To: The Panel for the Sunfield Project
From: Will Moore, Director – Maven Associates Limited
Date: 10 October 2025
Subject: **Response to Comments in Healthy Water Memo – Sunfield Fast-track Application**

This memorandum responds to Healthy Waters and Flood Resilience (HWFR) Memo comments dated 4 August 2025, which were provided following the Applicant's Substantive Application under the Fast-track Approvals Act 2024 (the "Sunfield FTAA Application"). The response has been prepared by Maven Associates (Maven) to support the Sunfield FTAA Application by addressing the comments on stormwater raised by HWFR.

Figure 1. Catchments

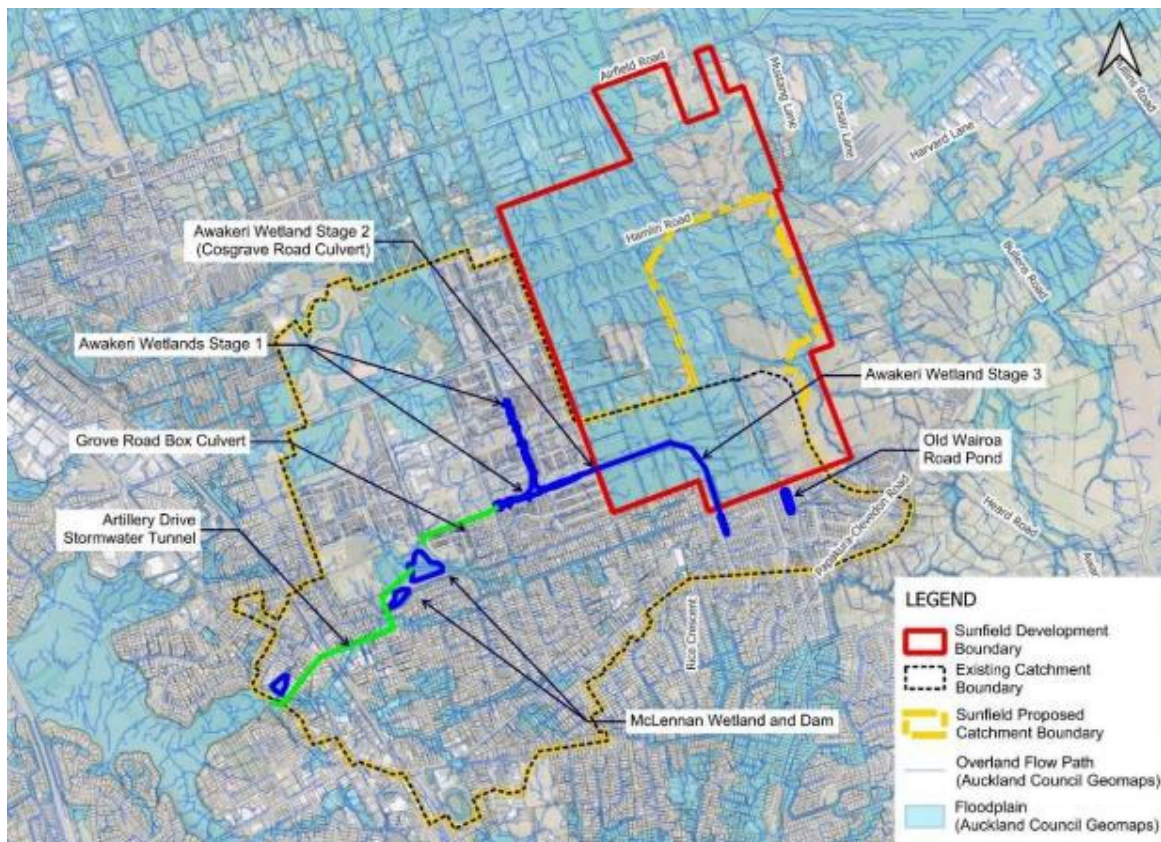
- 1.7 *To mitigate the effects of increased flooding caused by the proposed development, the Application proposes a complex scheme of stormwater attenuation ponds and catchment diversions. This includes diverting approximately 54.9 hectares of catchment from the Papakura Stream catchment to the Pahurehure Inlet catchment, as shown in Figure 1.*

Figure 4. Sunfield development site (red) underlain by Auckland Council Geomaps OLFP, Flood-Prone and Floodplain layers

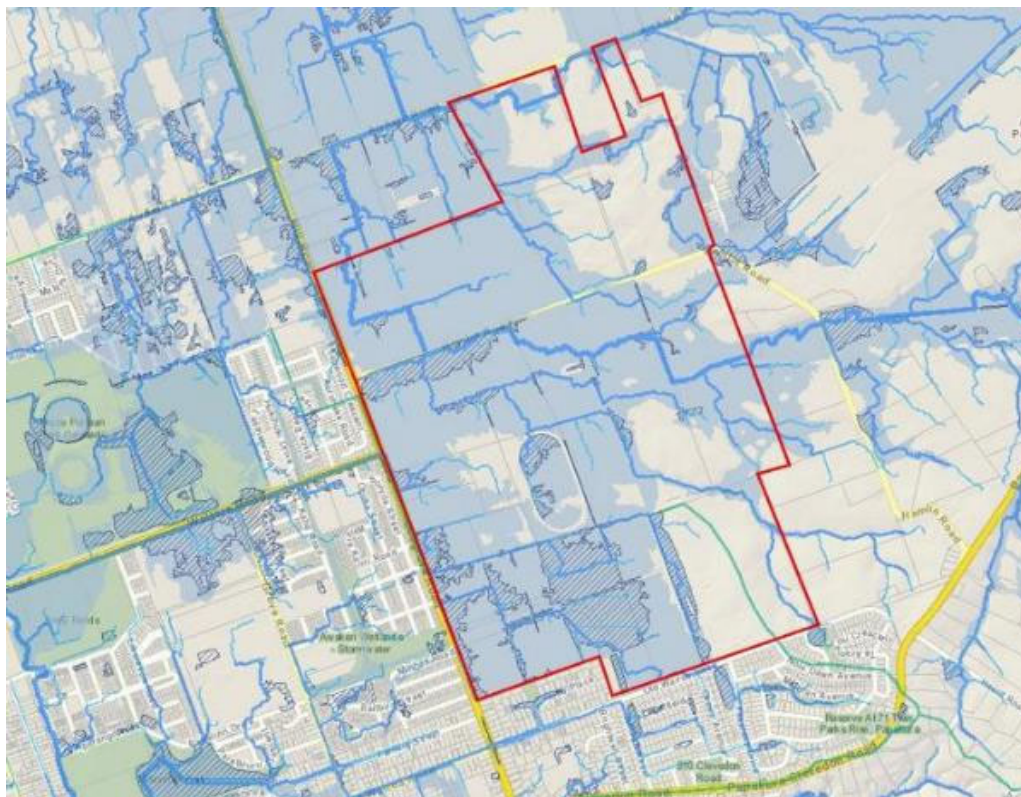
3.4. *The site and its surrounds are subject to significant flood hazards. Approximately 80% of the site is within the 1% Annual Exceedance Probability (AEP) flood plain (Figure 4). Flood depths are generally 200mm to 800mm deep across the site during this storm event.*

Figure 5. Extract from Auckland Future Development Strategy 2023 – 2053 showing land in the Papakura Stream Catchment to be removed from FUA – Sunfield overlain in red.

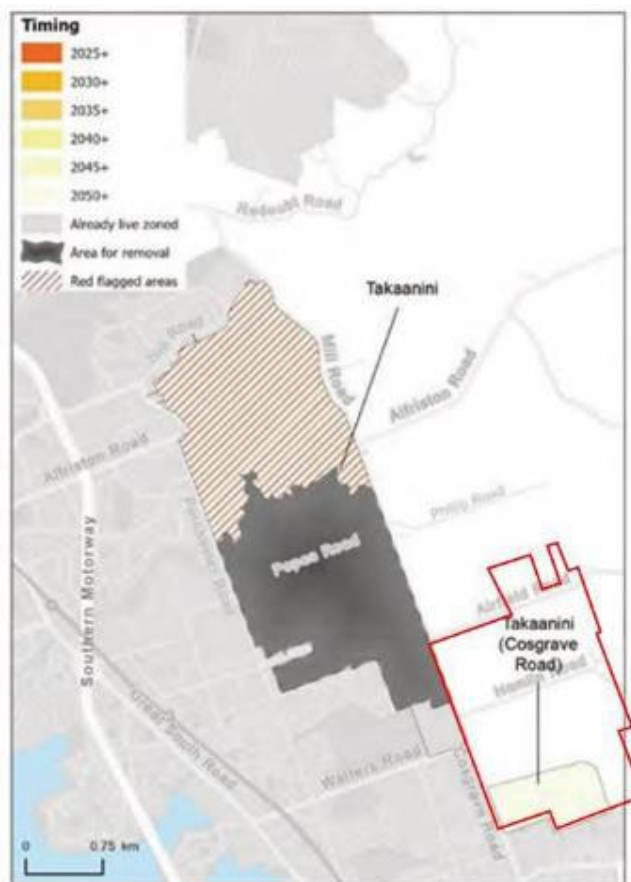
- 3.6. *Auckland Council’s Future Development Strategy 2023-2053 identified a large area of land in the Papakura Catchment downstream of the site, that was previously identified as a Future Urban Area, as either ‘red-flagged area’ or ‘area for removal’. The areas are considered to be inappropriate for future development due to being within the 1% AEP floodplain and underlain by peat soils. It was considered that flooding in these areas poses risks to life and property that cannot be feasibly mitigated. It is noted that the majority of the Sunfield Development was never considered as Future Urban Area (instead being zoned Rural – Mixed Rural) however, it is subject to the same flood hazards and underlain by the same peat soils as the Takanini ‘red-flagged area’ and ‘area for removal’ that was deemed inappropriate for future development.*

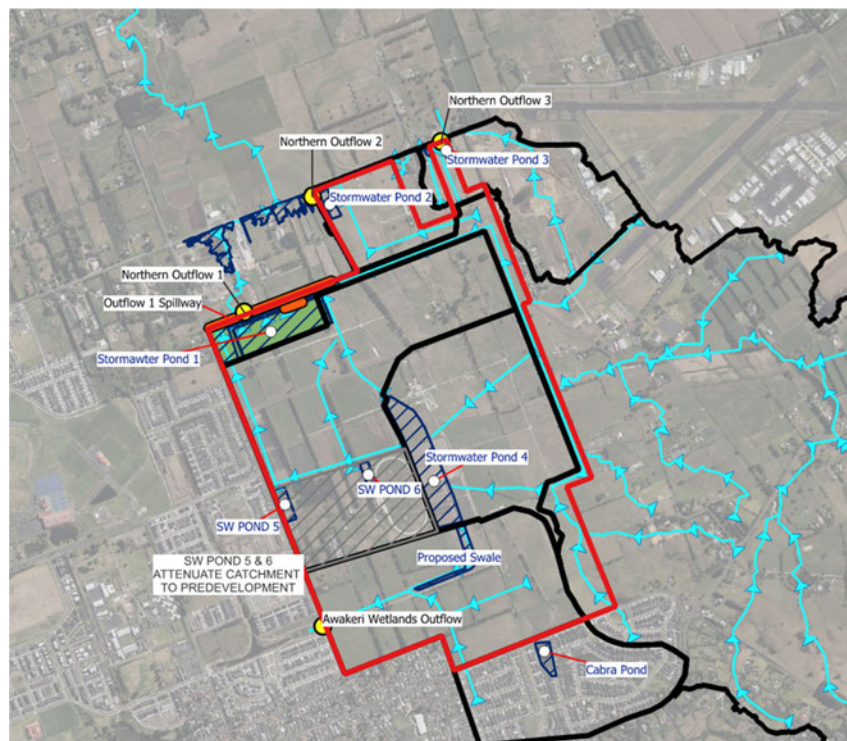
- 3.27. *It is proposed that the development site discharge its stormwater to a series of farm drains within private property downstream of the site in the Papakura Stream Catchment. These farms drains are well understood to lack capacity to manage even a 2-year ARI storm event without flooding (recent rainfall in the catchment, understood to be approximately 1.25 year ARI event resulted in widespread flooding within these farm drains). In the existing pre-development state, runoff generated from the site during low-intensity, frequent events is likely to pond within the site and infiltrate to ground where soil conditions allow. However, post development, with an increase in impervious coverage, even in these small intensity frequent storms, a significant volume of runoff will be directed to these farm drains which may create significant adverse impacts. The Application has provided no assessment into the capacity of these drains, or on the potential for an increase in both frequency and duration of flooding, during small intensity, frequent rainfall events.*

Detailed flood modelling has been undertaken as part of the development assessment, demonstrating that post-development peak flow rates are maintained at or below pre-

development conditions through the implementation of attenuation ponds. These ponds temporarily store stormwater runoff during peak rainfall events and release it at a controlled rate, preventing surges that could overwhelm downstream infrastructure.

Figure 8. Profile through the site showing proposed earthworks topography (orange line), compared to existing (green dash), the blue line shows the measured groundwater levels.

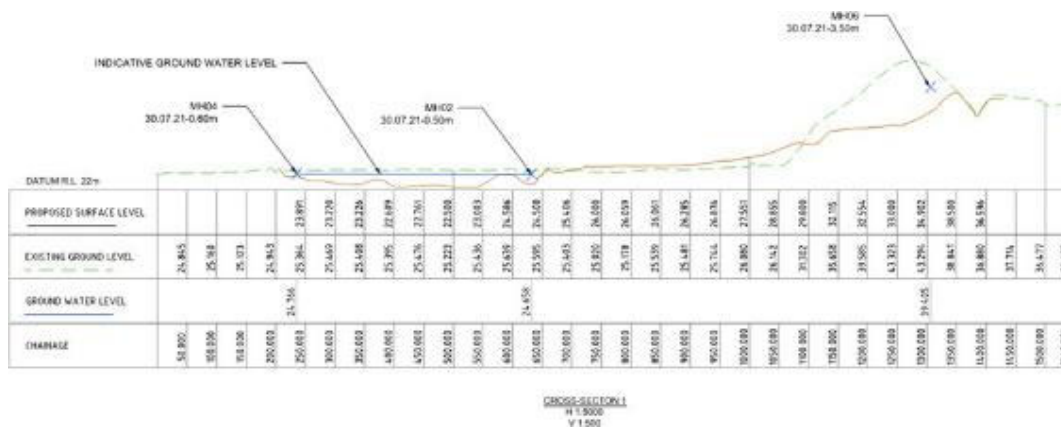
to how groundwater will be managed in relation to the ponds and conveyance channels, noting that they are currently shown to be cut to below existing groundwater levels measured and observed across the site. However, the stability analysis included in the Geotechnical Assessment Report appendices appears to be based on the assumption that the groundwater level will be lowered to the permanent long term, low water level in the channel. This approach will require careful consideration of the area affected by this drawdown and the implications of settlement effects on the proposed development and associated infrastructure. As shown in Figure 8, within the basins and channels, earthworks are proposed well below the existing groundwater table.

Please refer to Geotechnical Memo supplied by LDE which addresses this.
